Appeal of Planning Commission Resolution No. 26-05 Regarding Coastal Development Permit No. 19-012 (25200 Pacific Coast Highway, APNs 4459-013-021 and 4459-014-018; Owner, PAR PCH, LLC; Appellant, Jun Hall for Concerned Citizens of Malibu Road, Inc.)

Amended[1] Malibu City Council
Special Meeting Agenda

Wednesday, August 19, 2026

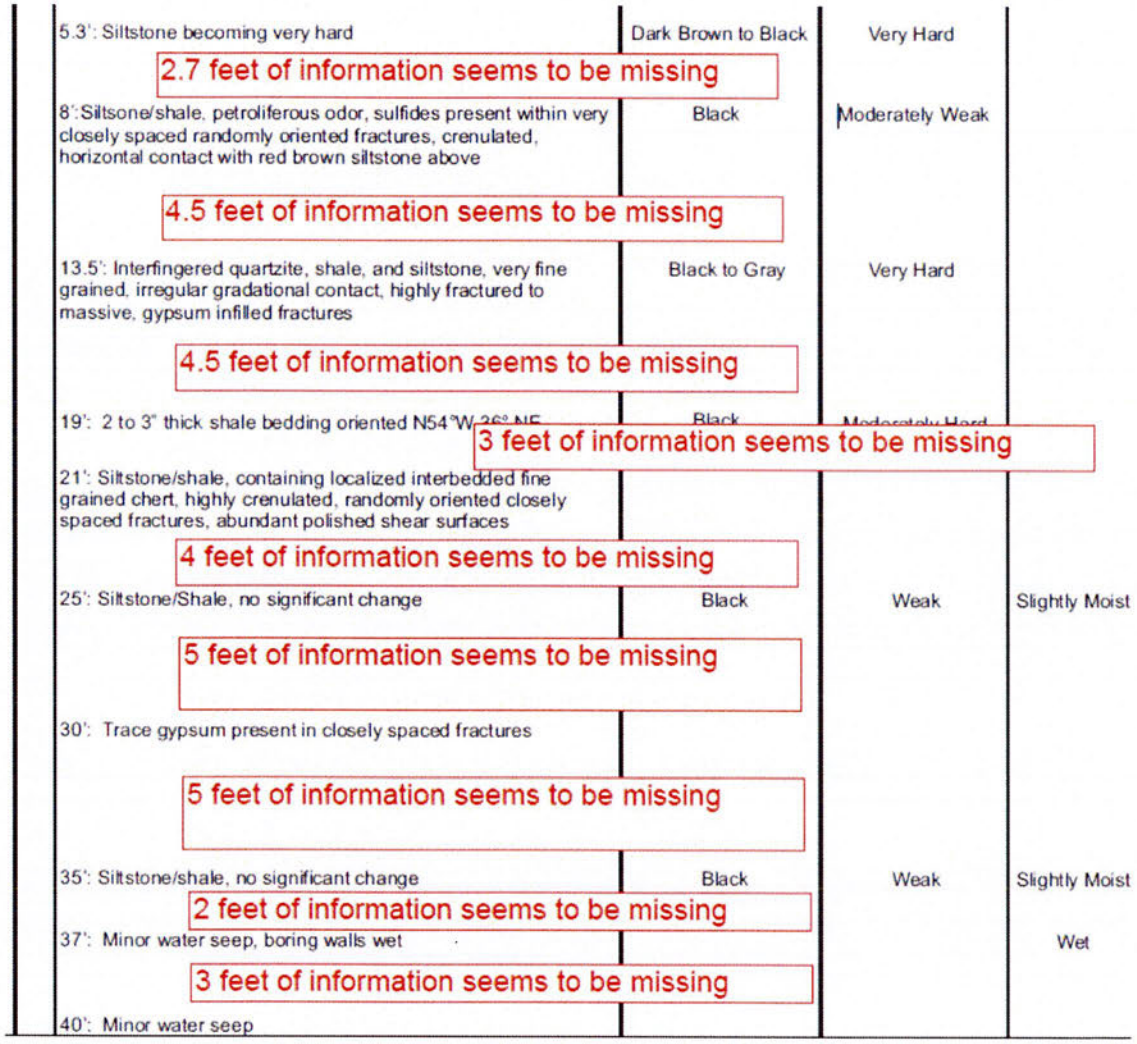
The concerns regarding the characterization of subsurface materials in Feffer's borings remain unaddressed. Specifically:

- Older consultants' reports documented crushed, disturbed, or sheared materials consistent with landslide deposits, while Feffer logs classify similar intervals as "bedrock" without explanation.
- Gaps in log descriptions at depth and a lack of detailed material characterization were not addressed and did not meet the industry standard of care.
- No explanation was provided for discrepancies between historic logs and Feffer's own interpretation.

As stated in the prior technical letter, continuous subsurface investigation is critical to defining landslide geometry and failure mechanisms. Continuous boring logs are essential. Industry standards require logging every vertical inch of the borehole and documenting lithology changes, shear zones, bedding attitudes, fractures, clay seams, and disturbed materials. Terms such as *smashed*, *jumbled*, *pulverized*, *reworked*, *slickensides*, and *polished shear surfaces* are commonly used to describe materials disturbed by landslide movement.

77 Caissons With Tiebacks

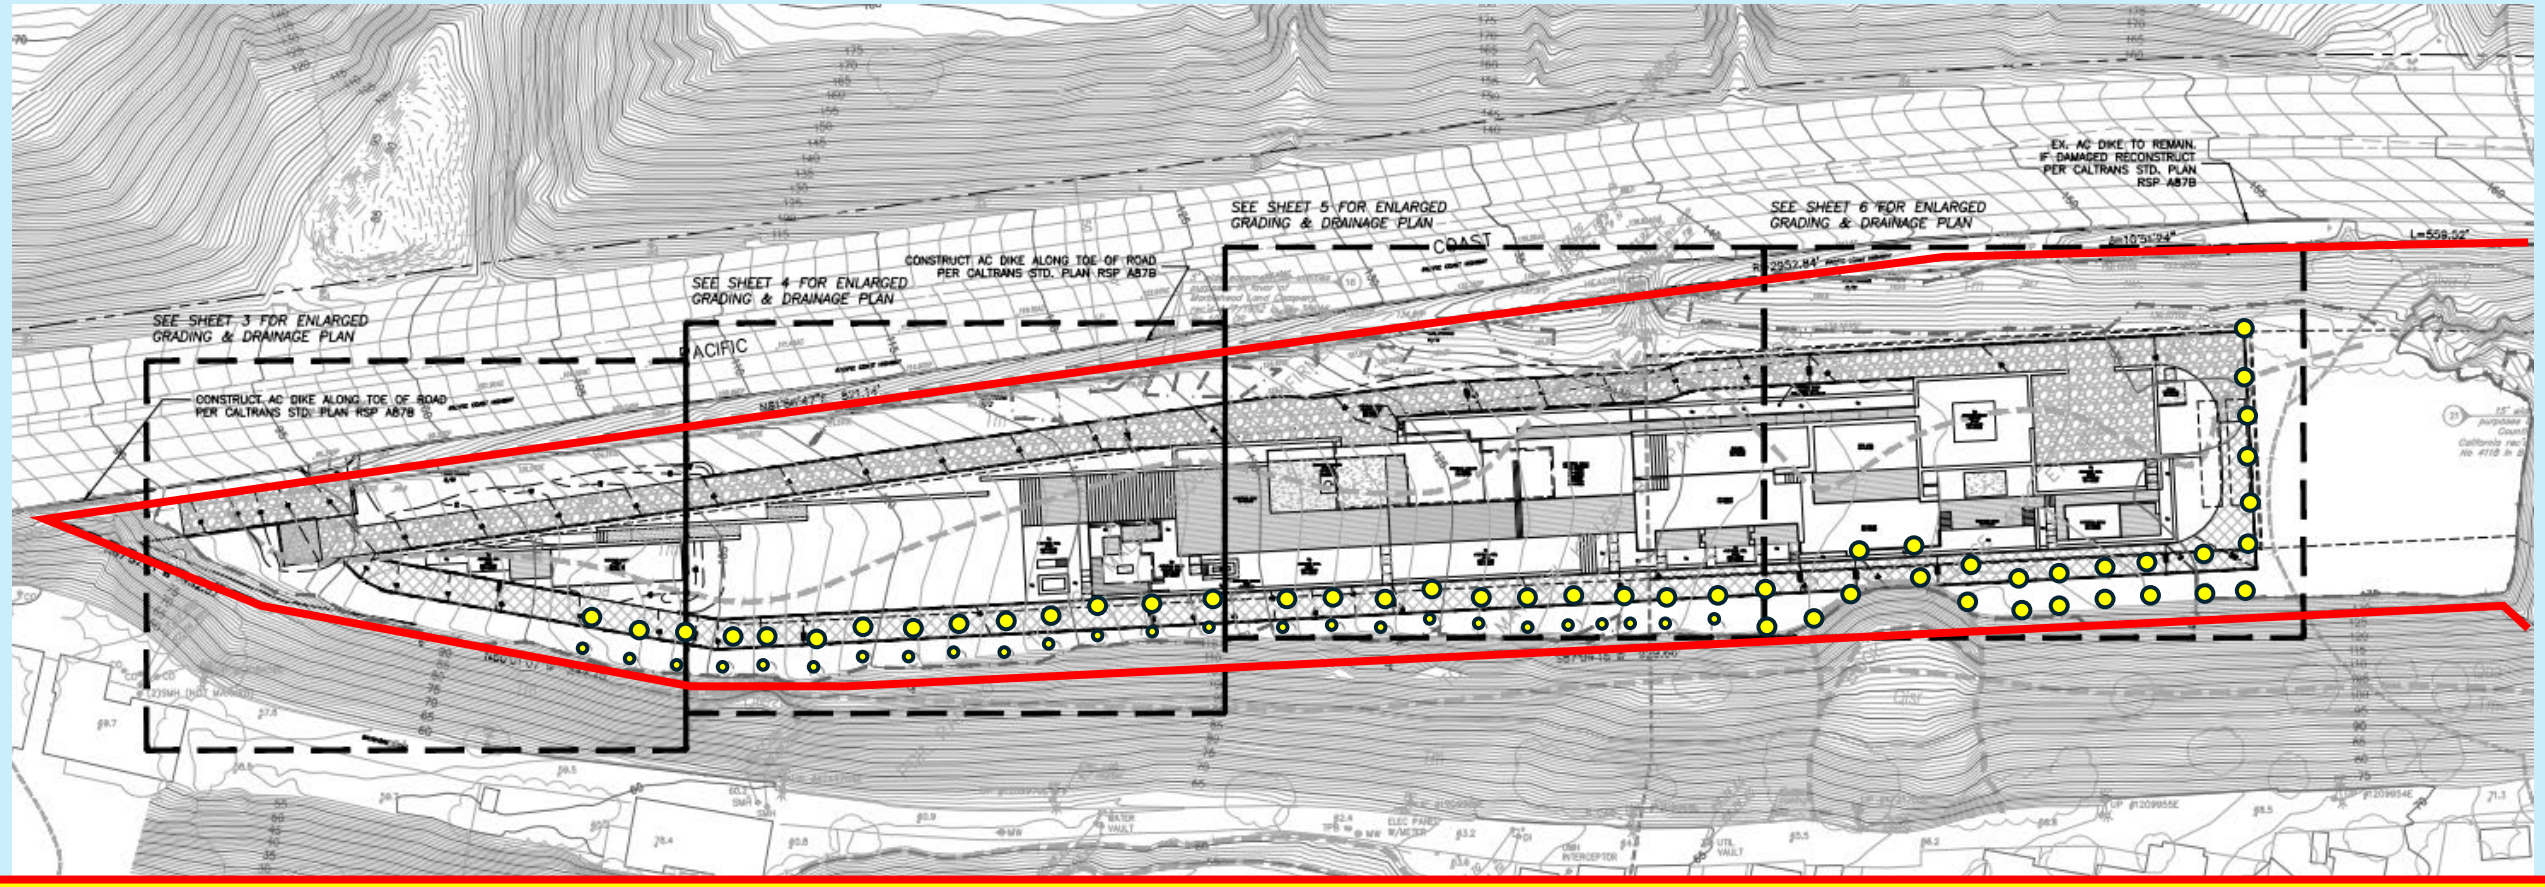
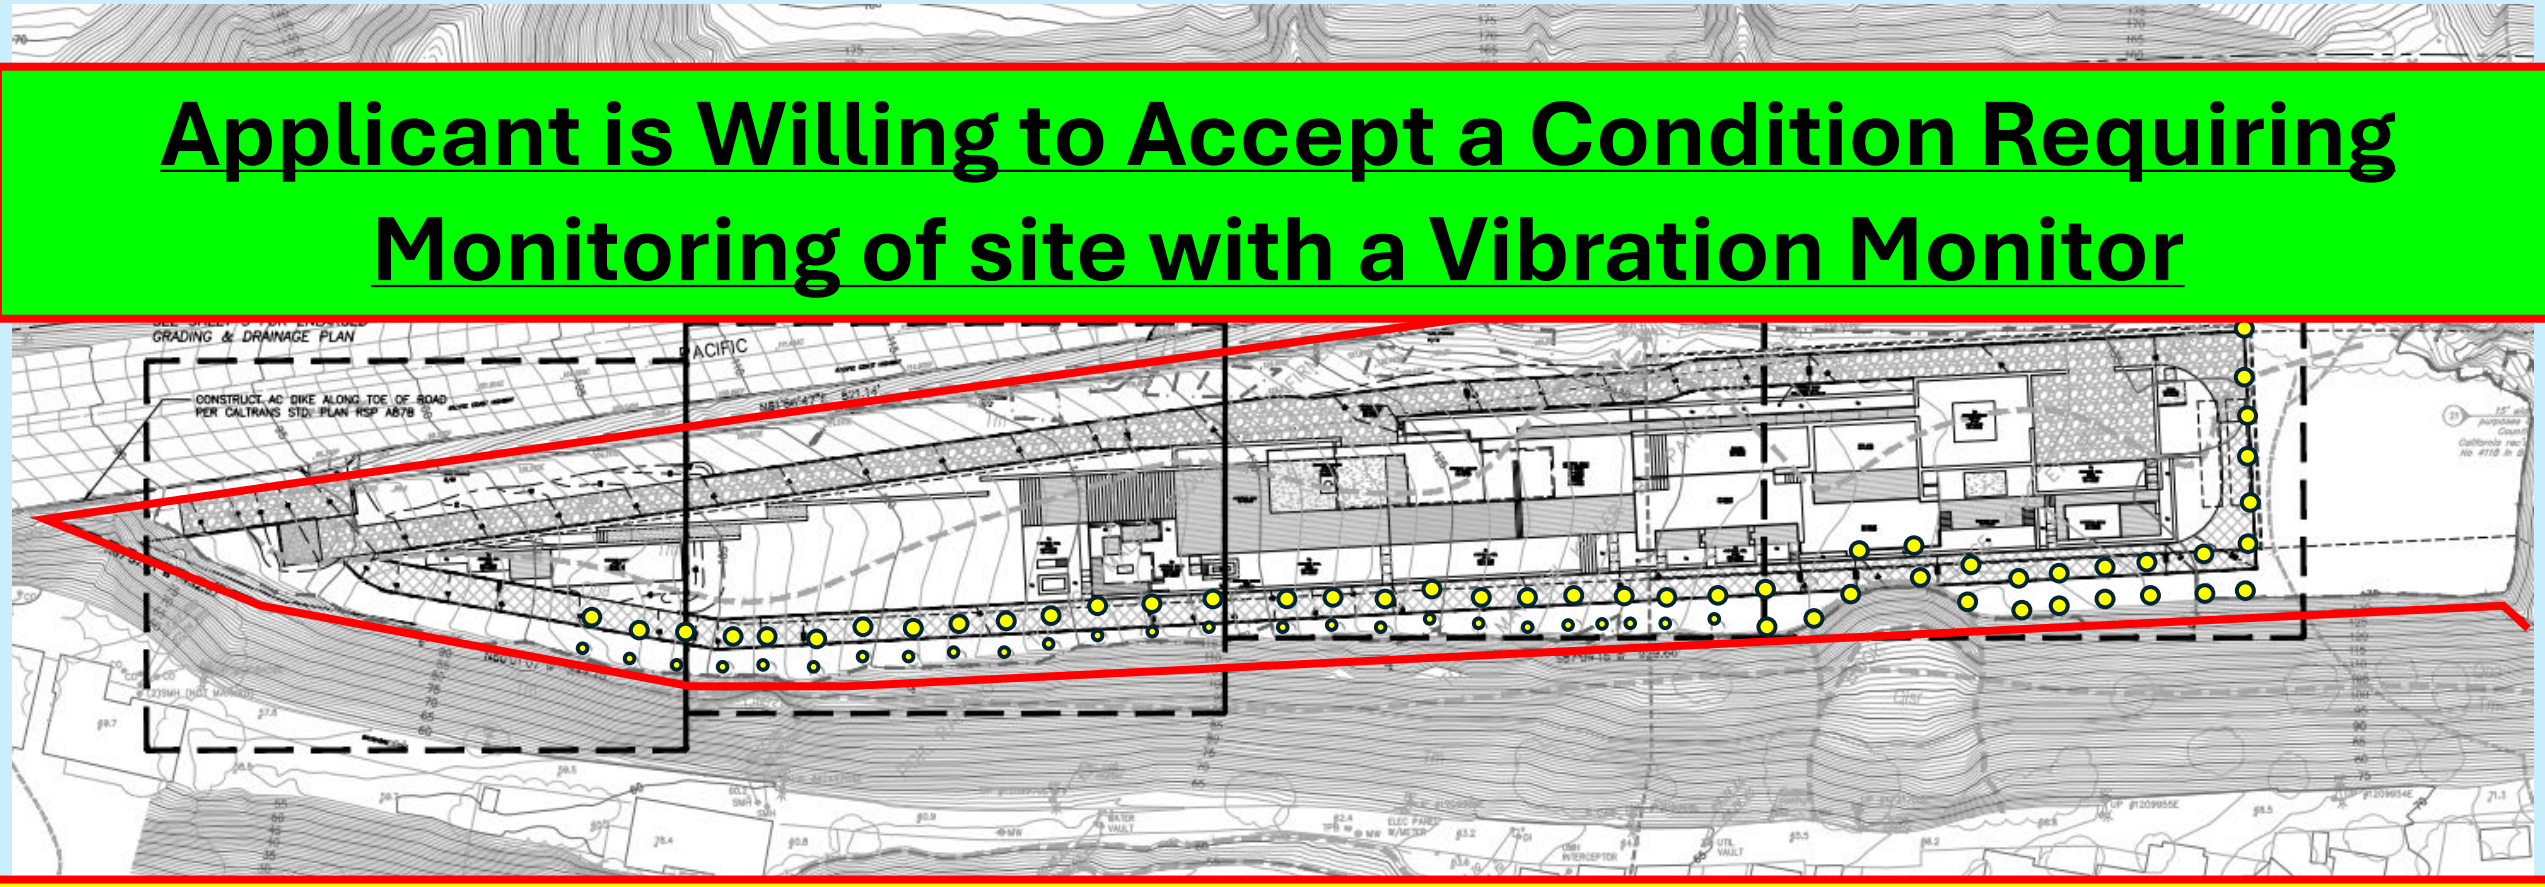
Proposed Caissons & Tiebacks Will Stabilize Building Site, Hillside to Bayshore Drive, and Pacific Coast Highway

Applicant is Willing to Accept a Condition Requiring Monitoring of site with a Vibration Monitor

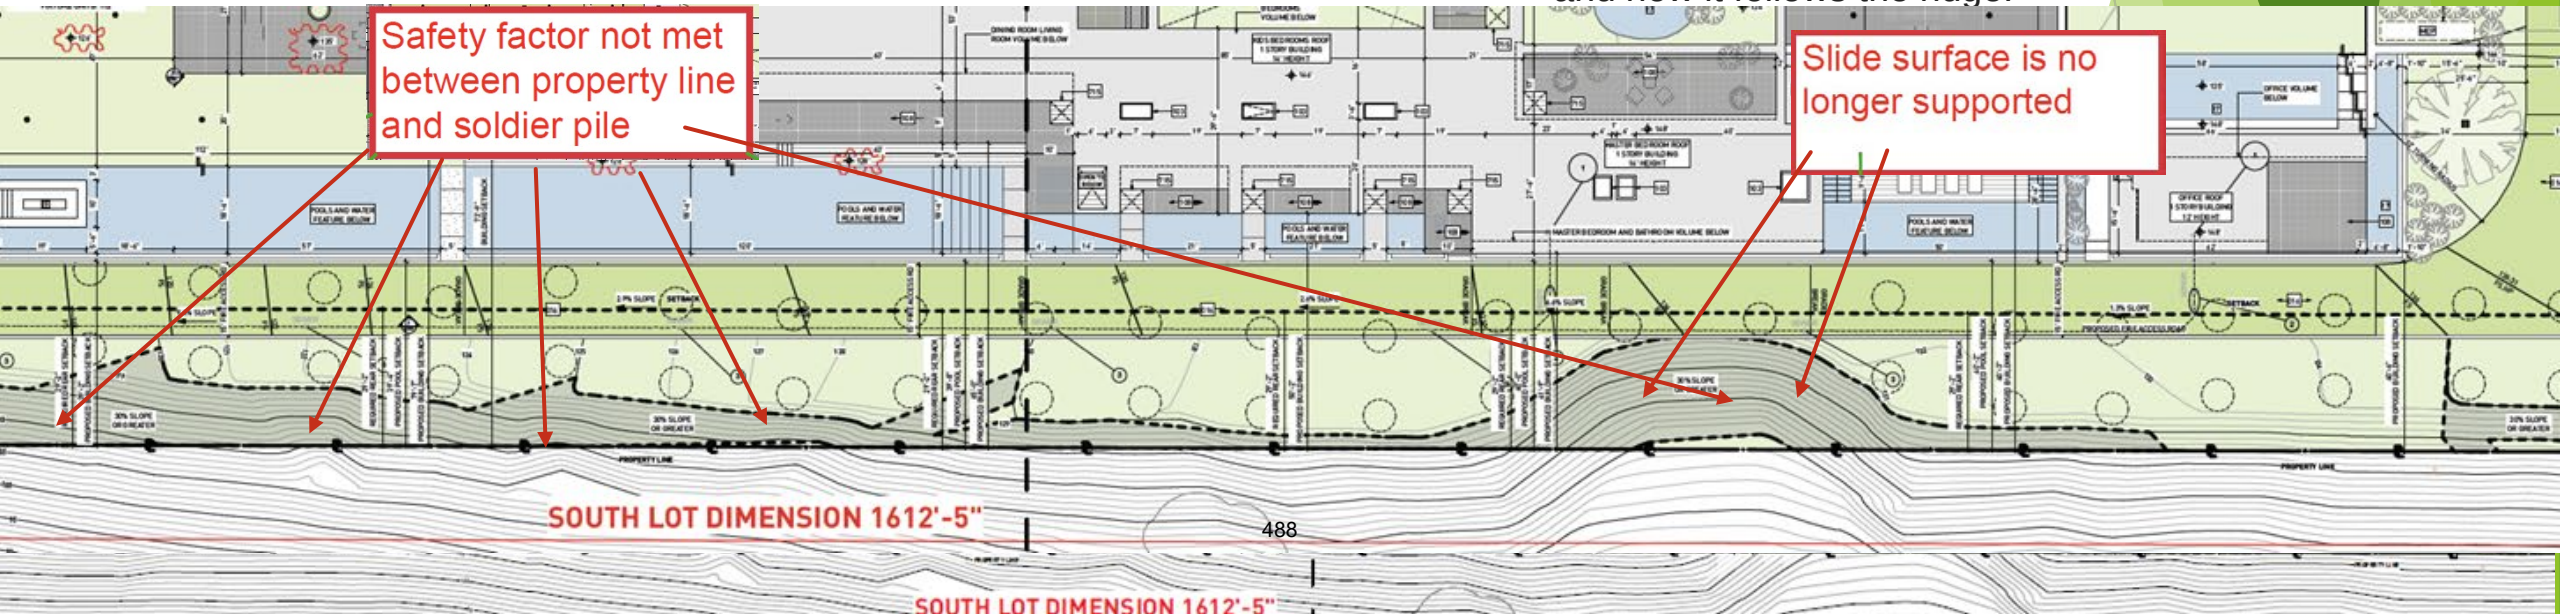
This is where the safety factor is clearly not met – They **moved/relocated** the soldier piles a few feet to avoid a slope variance and now they need a variance because there is space between the property line and the soldier piles where the safety factor is not met.

In addition, they are no longer supporting the slide in front of the MASTER area, and this would cause a slide into adjacent properties. This first image is before they moved the piles and shows the property line, it used to follow a straight line and now it follows the ridge.

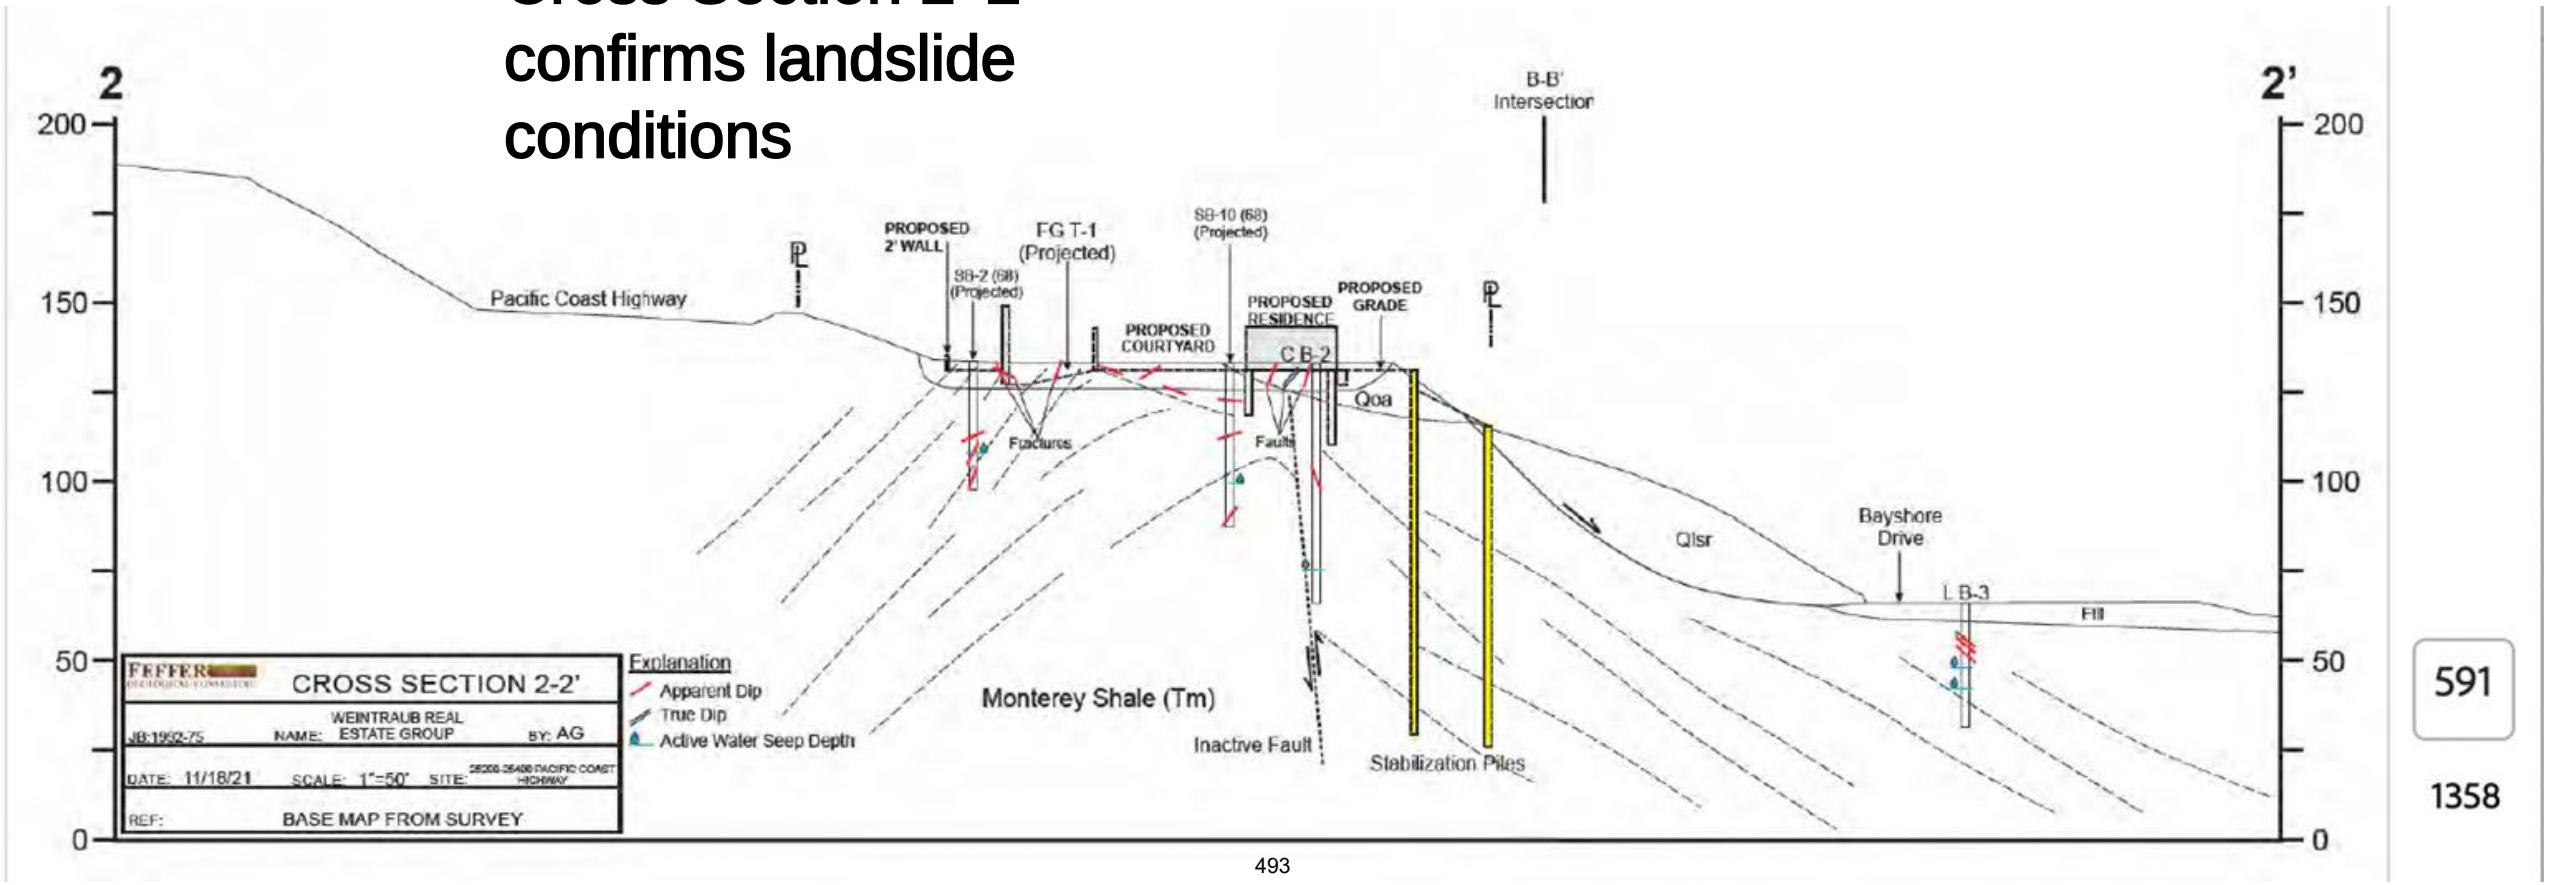
Very FAR OFF the required 1.5 static factor of safety

- Required minimum (LIP §9.4(D)): **1.5 static**
- Calculated results: **1.076 - 1.234**
- Values near **1.0 = marginal equilibrium / instability**
